RECEIPT DATE: 8.15.22 **ONSITE SEWAGE DISPOSAL SYSTEM**

PROPERTY ADDRESS: 13980 Monticello Drive

The OSDS Plan for 13980 Monticello Drive has been reviewed with the following comments:

**ONSITE SEWAGE DISPOSAL SYSTEM DESIGN PLAN**  
PROPERTY OF CHARLES AND DENISE SHARP  
LOT 1  
PLAT No. 18440  
LIBER 20021, FOLIO 47  
TAX MAP-9, GRID-19, PARCEL-327  
ZONING: RC-DEO  
SCALE: 1" = 20'  
JOB NO.: 3666  
DATE: AUG 30, 2021  
SHEET: 1 OF 1

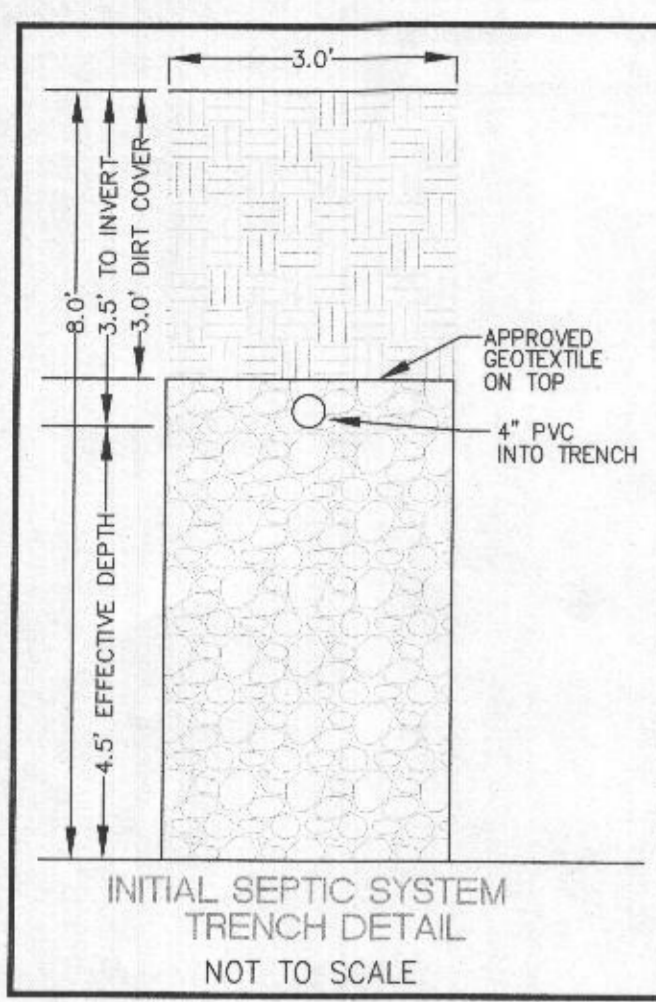
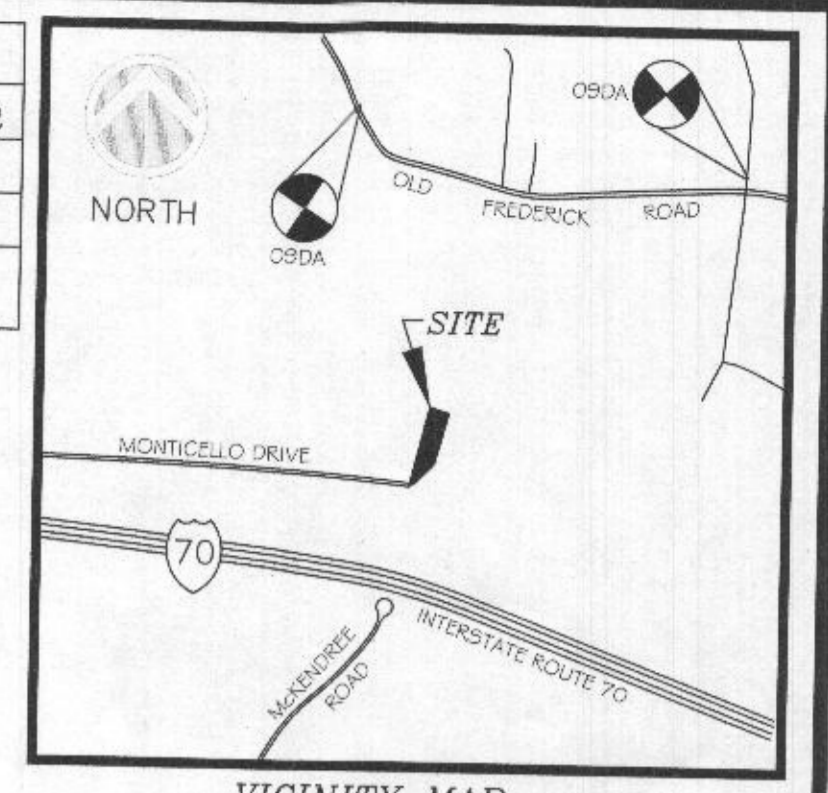
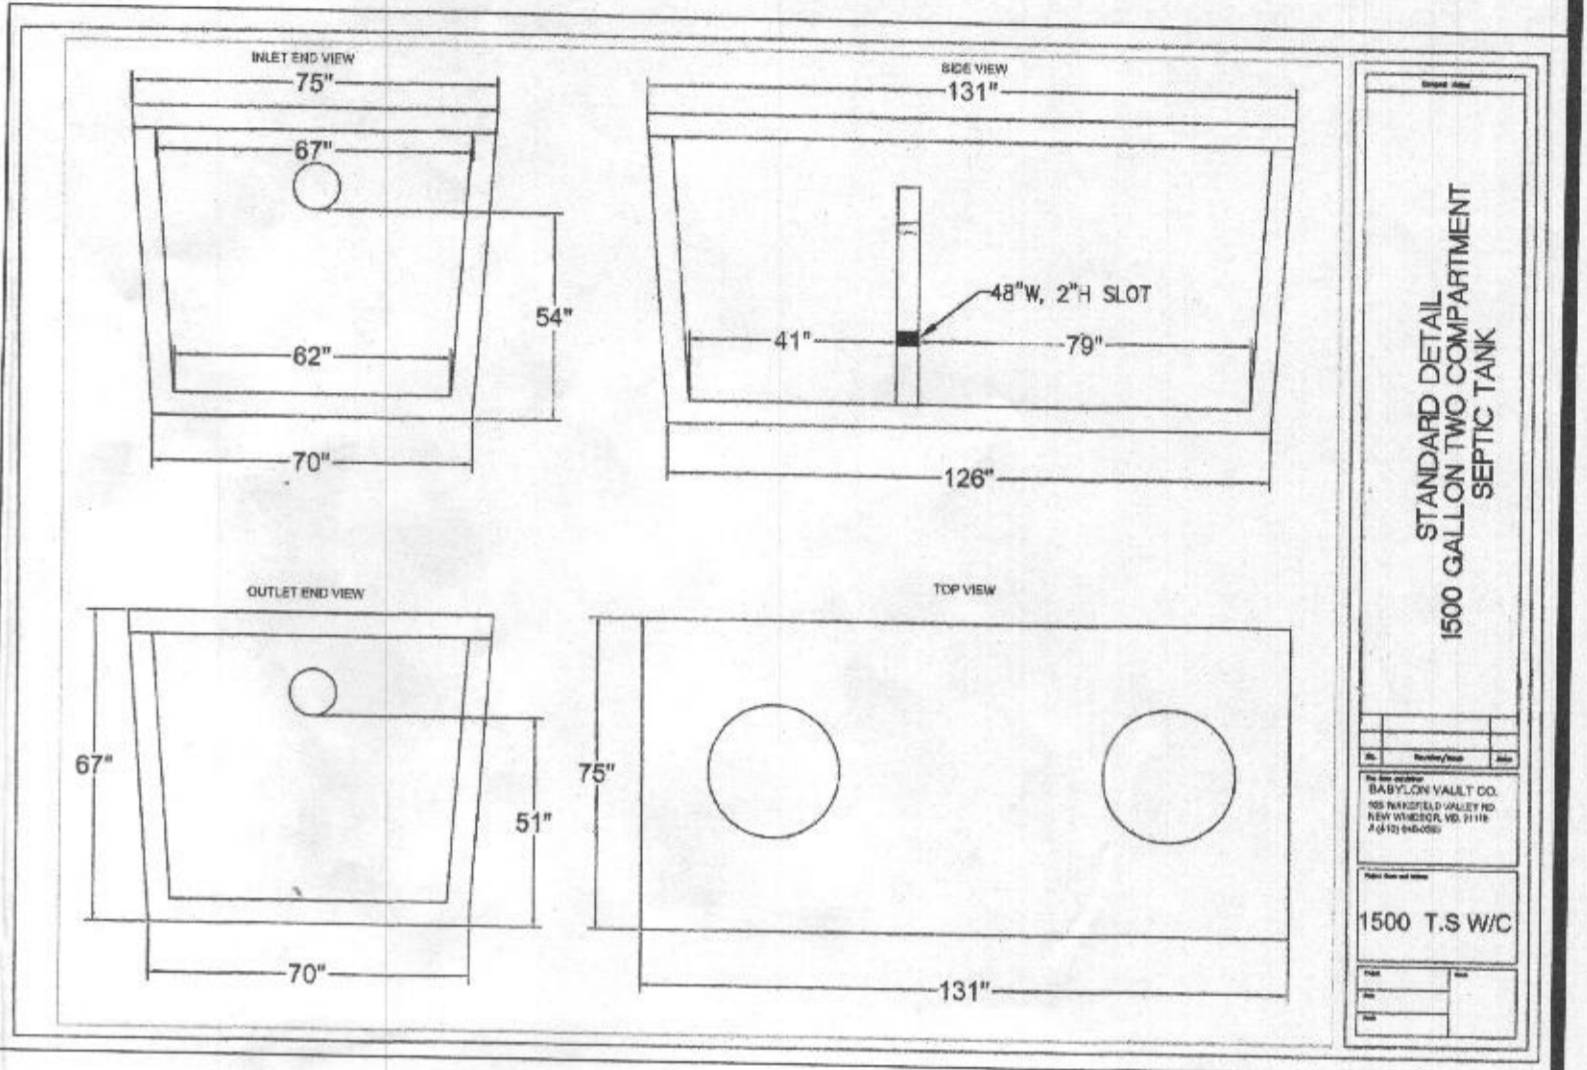
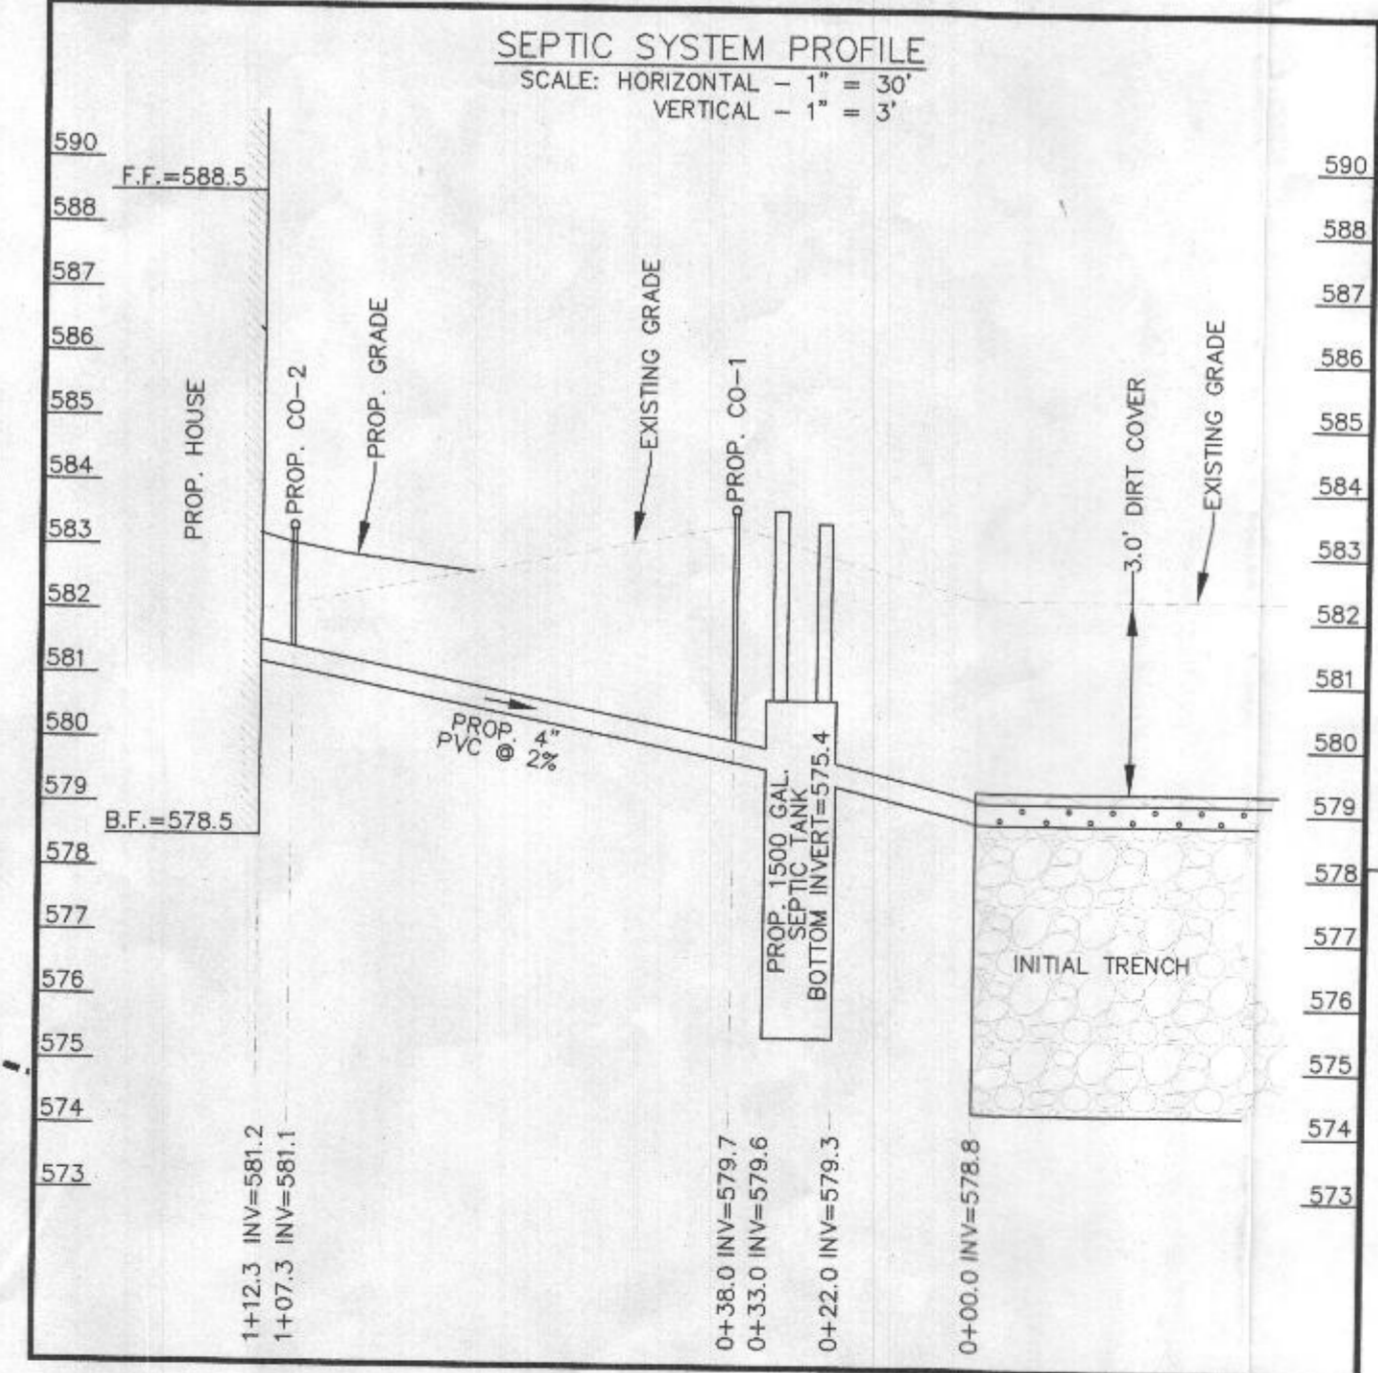
This is a follow-up to my last email. In addition to your stated changes in your email dated Oct. 1<sup>st</sup>, if you were to add additional area to the well box further up/away from the swale while meeting the setback to the drywell, then we will just redline the perc cert plan on our end to avoid another perc cert plan review.

Can you bump the swale down a bit to help maximize the distance of the well box to the swale? You will need to revise the perc cert plan with the new well box location and add a note acknowledging due to the proximity of the well box to the swale and the concern for road salt, the replacement well must be drilled on the upper end of the well box. The note should be on both the PC and OSDS plan.

Is the well box 50 feet away from the swale?

Is the swale along the driveway and next to the well box necessary? Is there any way to adjust it or the well box to make the 50 foot setback?

If you can't make the driveway setback to well box, then you could show a large rock or some other permeant structure (i.e. bollard) in between the driveway and well box.

1. The proposed swale is within 50 feet of the well box (The setback is 100 feet if it's a wet swale).
2. The well box is within 10 feet of the driveway.
3. Perc test hole P4 is labeled P8.

I added two bollards for the well box protection and shortened the dry swale to half the length and doubled the width to move away from the well box. The check dams are also taken out as they are not needed at this end so this swale will not hold any water, even at rain events. Please review the attached PDF of the OSDS and let me know if this is okay to submit.

No, the existing well is only 25' from the beginning of the swale but the swale is sloped away from the well.

The well box can be adjusted as shown in red on the attached. Can I just make the change on this plan or do we need to submit a Percolation Certification Plan for that?

The dry swale or a permeable pavement are the only two options for the beginning part of this driveway as I used Non Rooftop disconnect to the maximum square footage for the rest of the driveway. The permeable pavement is not a preferred method as it's costly and hard to maintain but if you prefer that over the dry swale, I can make the change.

1- The proposed swale has gravel check dams for erosion control where it is steeper then 4% but it will not hold water.

2- The existing well box corner is about 20' off the property line on the east side and even less on the west side. The proposed 12 wide driveway is the minimum with for single family dwelling so even if we slide the driveway edge to the property line where it will require a grading easement, we will still be only about 8 feet off the well box corner. Can we get a special exception type approval for this site as the offset encroachment is clipping a small corner area?

3- The perc test P4 is corrected on our files and we can resubmit for that or if possible, it could be hand fixed on the prints already submitted.
